ADDENDUM 1

CSP 23-27

GYMNASIUM ADDITIONS/IMPROVEMENTS FOR CAVAZOS & TREVINO ELEMENTARY SCHOOLS

ADDENDUM NO: ONE (1)

**BUILDING
SECTIONS**

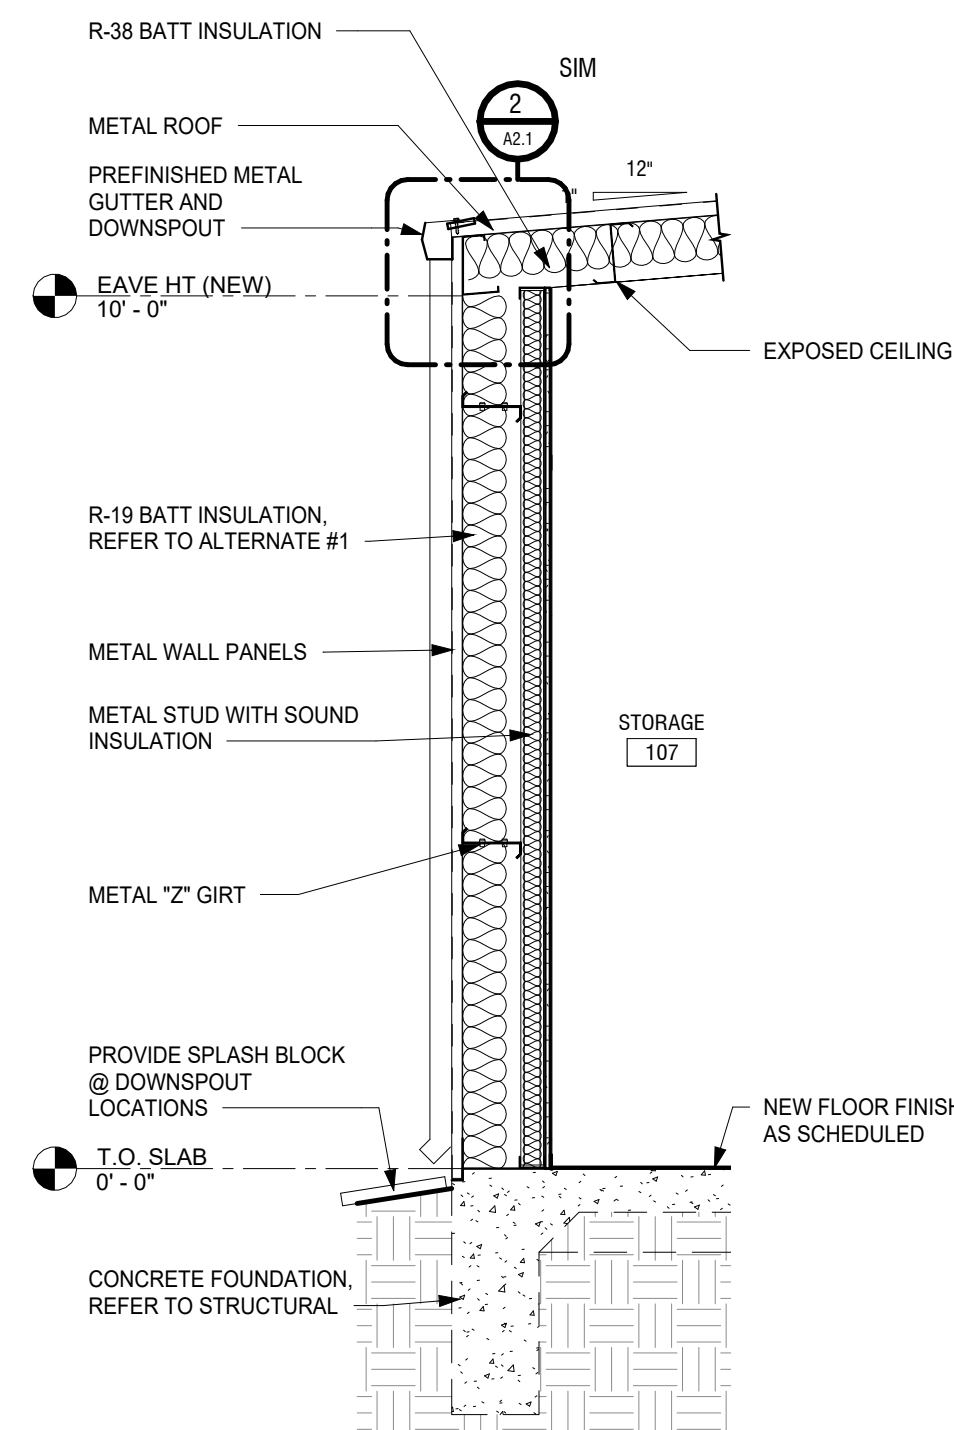
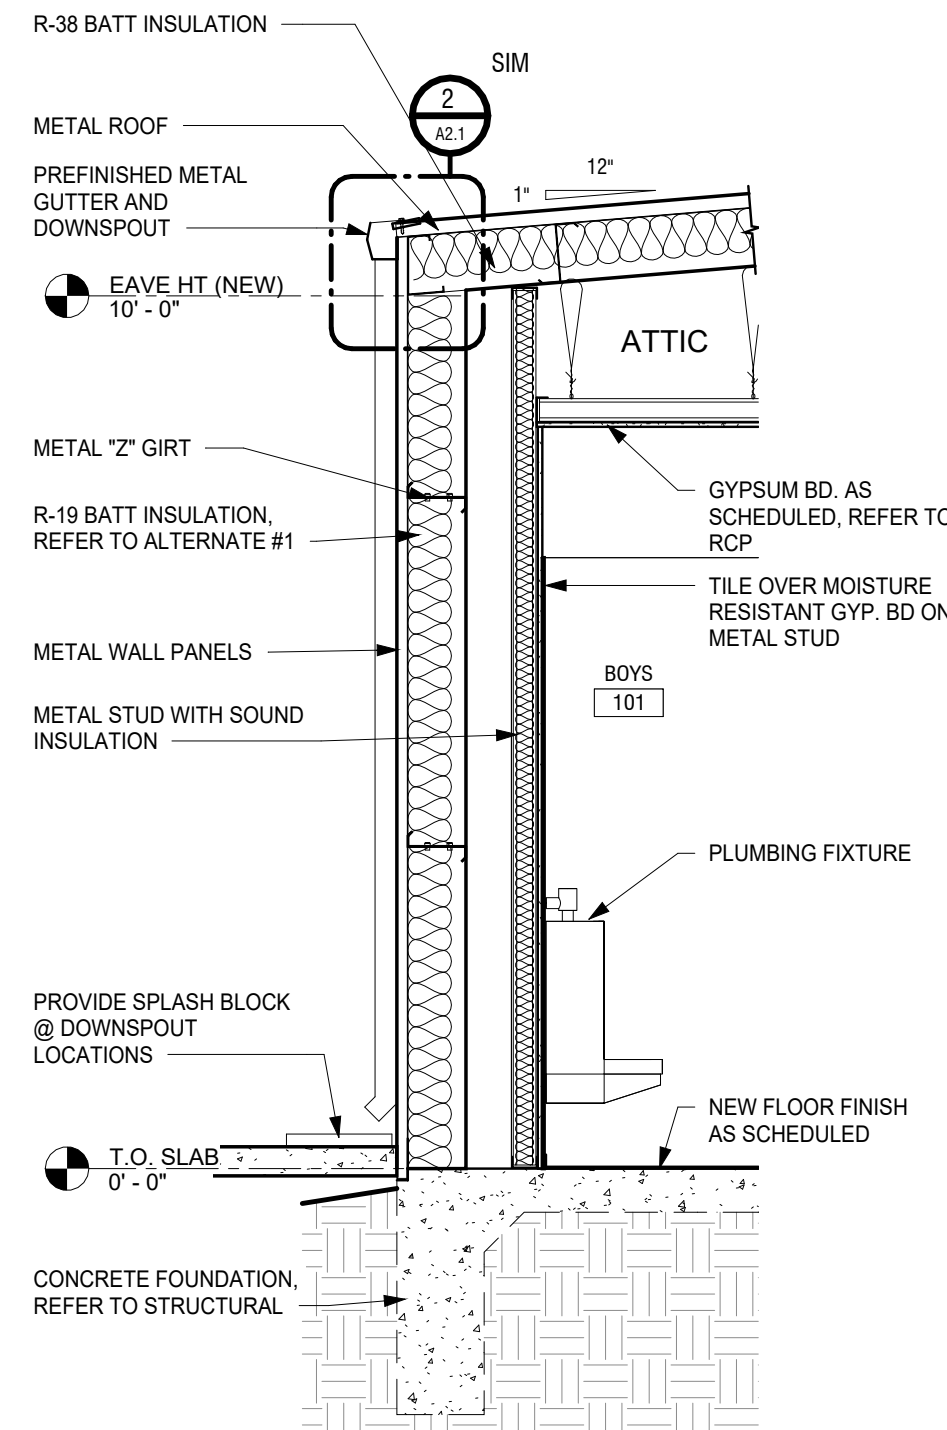
3. SHEET A4.0 BUILDING SECTIONS (INCLUDED HEREWITH)
 - a. At Sections 1/A4.0, 2/A4.0, and 3/A4.0 modify notes as shown for “R-19 BATT INSULATION REFER TO ALTERNATE NO 1” and replace with note “EXISTING INSULATION TO REMAIN”

- b. At Sections 1/A4.0, 2/A4.0, and 3/A4.0 delete notes “EXISTING STRUCTURE TO BE RE-PAINTED” and replace with the note “EXISTING STRUCTURE TO REMAIN”

- c. AT Sections 1/A4.0, 2/A4.0, and 3/A4.0 delete notes “BASE TRIM AS SCHEDULED”
4. SHEET A4.2 WALL SECTIONS AND DETAILS (INCLUDED HEREWITH)
 - a. At wall section 2/A4.2 delete note “REPLACE EXISTING SHEATHING PANEL OVER EXISTING WALL FRAMING REPLACE WITH NEW SHEATHING PANEL REFER TO SPECS” and replace with note “EXISTING SHEATHING PANEL OVER EXISTING WALL FRAMING”

4 WALL SECTION DETAIL - TRANSITION NEW TO EXISTING
1/2" = 1'-0"

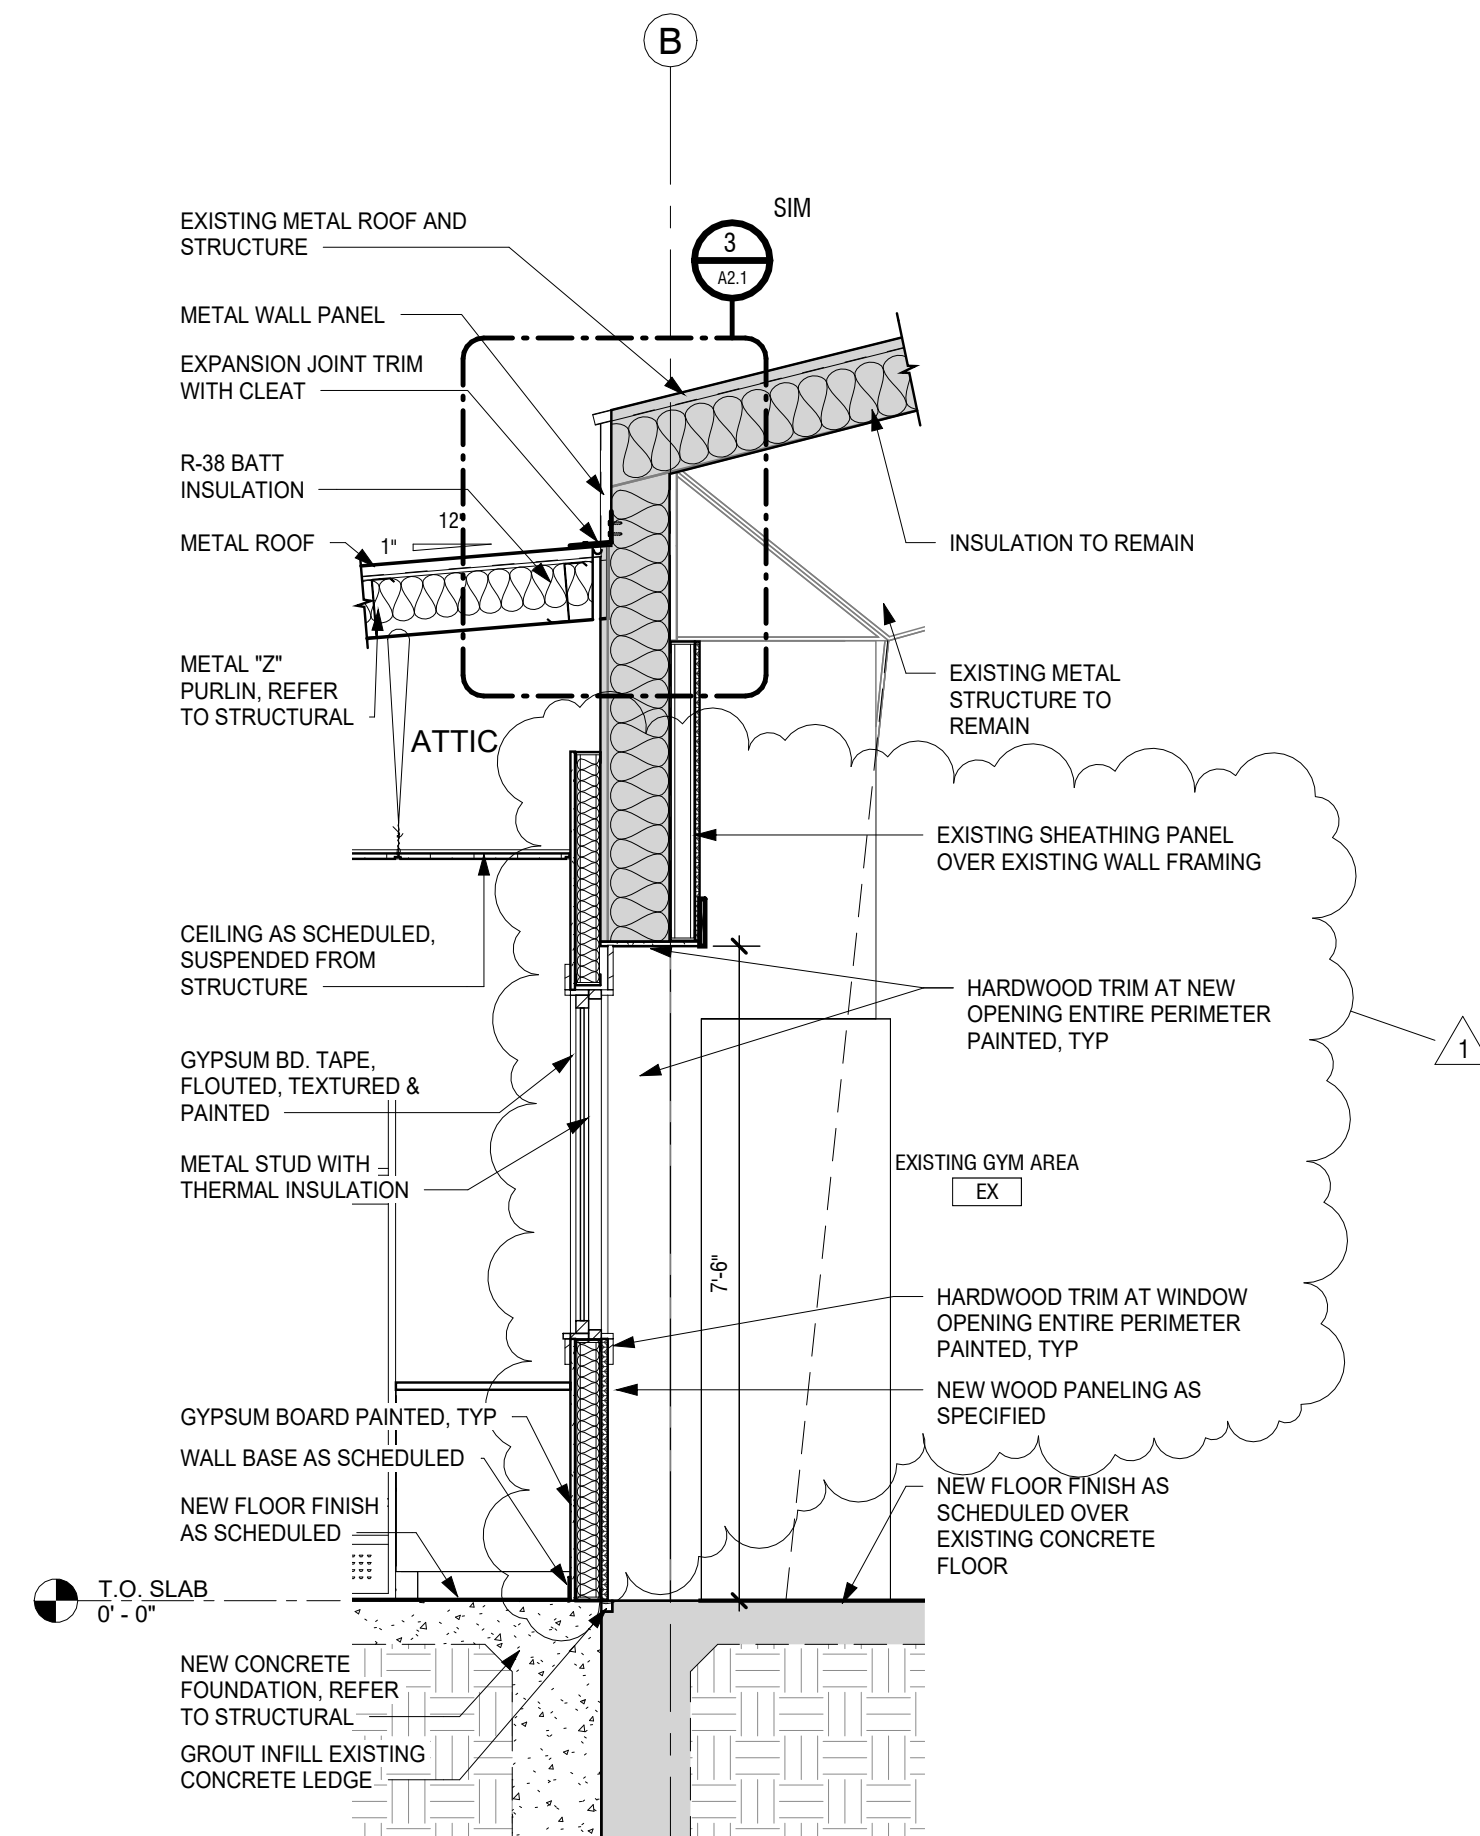
- b. At wall section 4/A4.2 modify wall section as shown and update notes as shown
5. SHEET A5.2 INTERIOR ELEVATIONS (INCLUDED HEREWITH)
 - a. Delete entire sheet A5.2 and replace with sheet A5.2 included herewith
